PROFILE & DECK PLAN
S. S. N^{os.} 261 & 2.

Bartrams 261-2-3-4.

Profile & Decks

S.S. * "LHANOVER" No. 261.

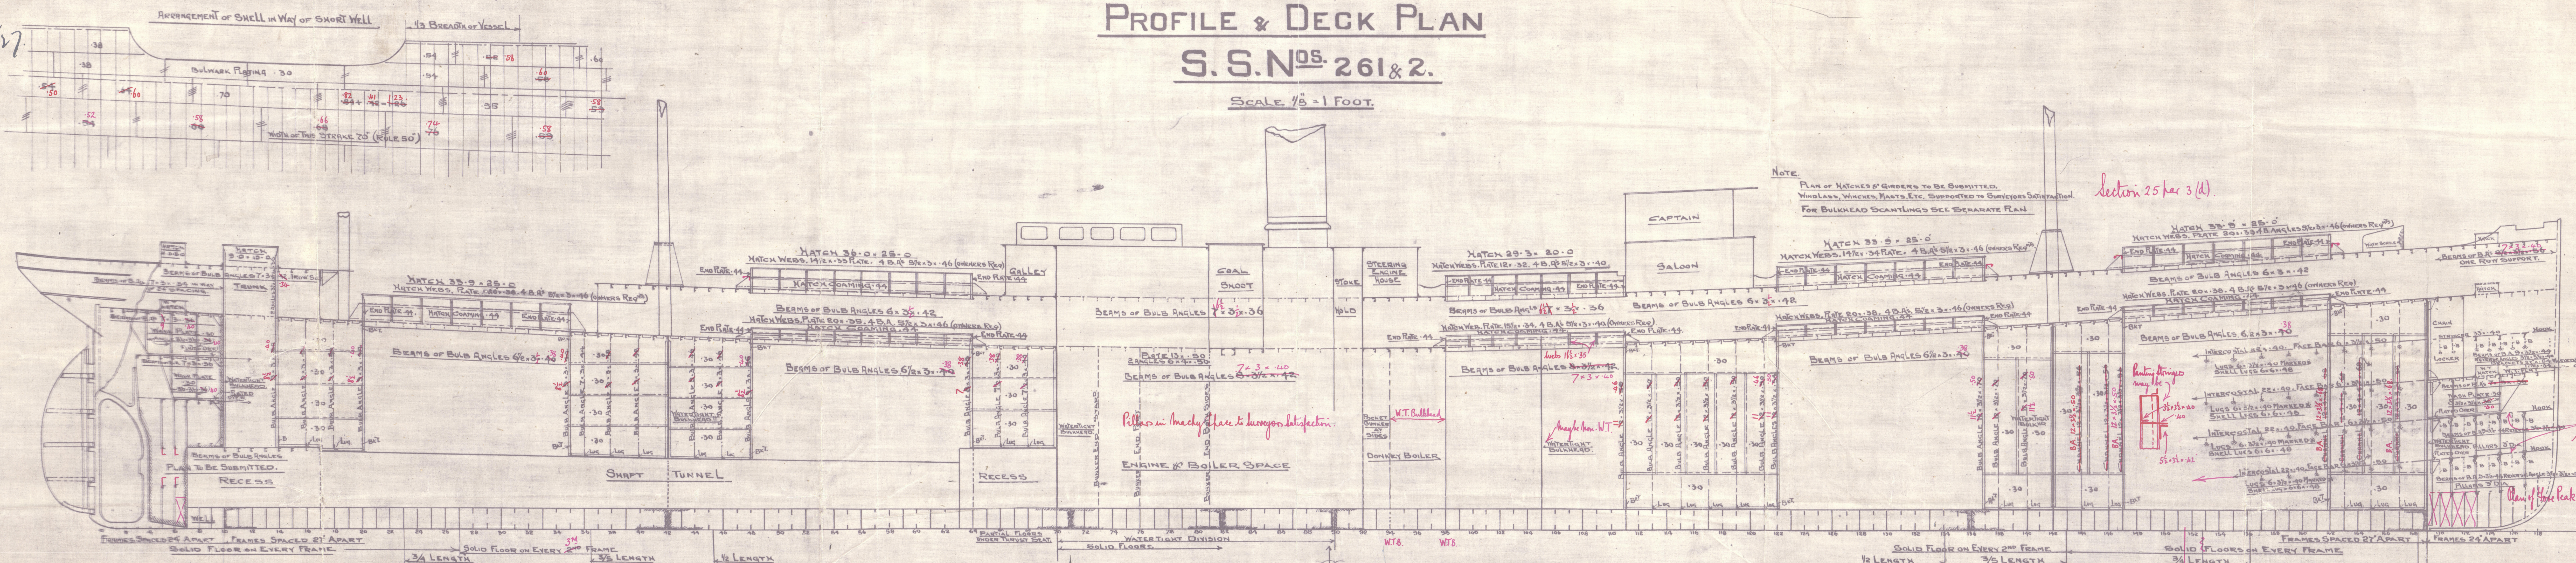
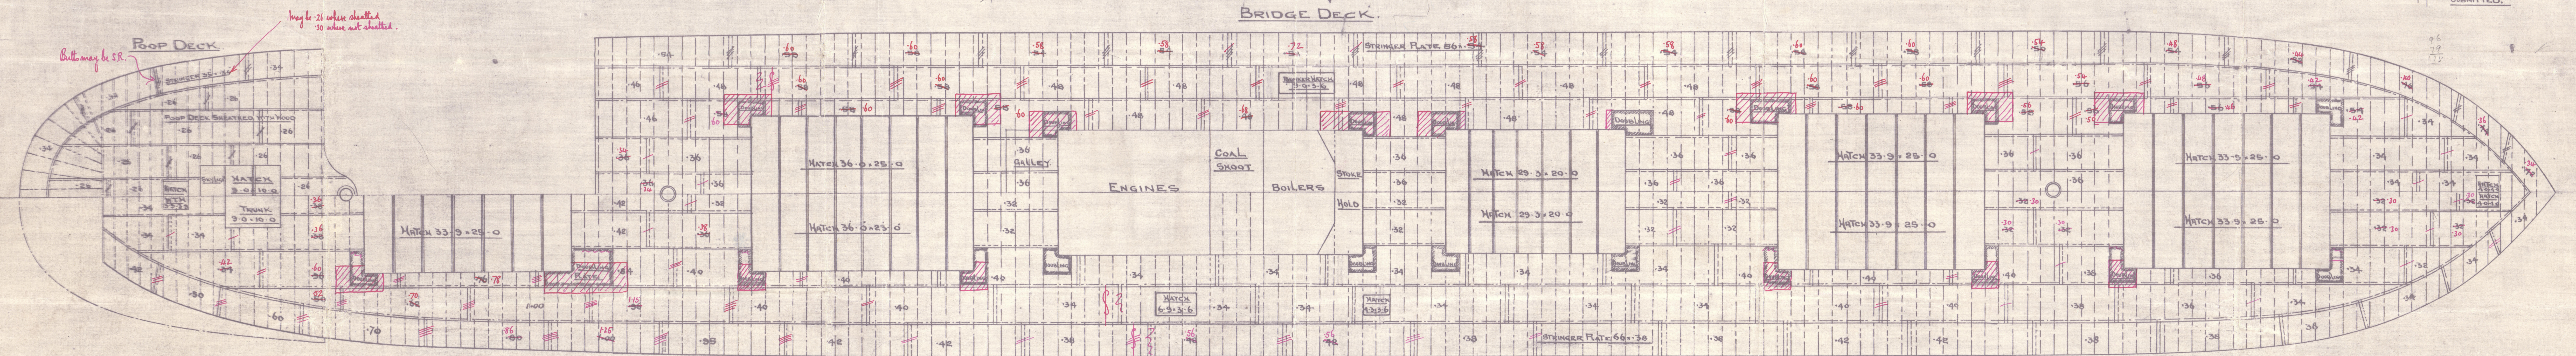
NOTE.
PLAN OF HATCHES & GIRDERS TO BE SUBMITTED,
WINDLASS, WINCHES, MASTS, ETC. SUPPORTED TO SURVEYORS SATISFACTION.
FOR BULKHEAD SCANTLING SEE SEPARATE PLAN

Section 25 par 3(d).

Pillars in Machy face to surveyors satisfaction.

Maybe non-W.T. = 2

Stringer $35' \times 34'$
Shell Connections $5' \times 5'$

Plan of Horse Peak to be submitted.

NOTE. BOTTOM STRENGTHENED FORWARD
AS PER RULE. PLAN TO BE SUBMITTED.
PLAN OF PAINTING ARRANGEMENT TO BE
SUBMITTED.

May be .26 where sheathed
.30 where not sheathed.

Butto may be S.R.
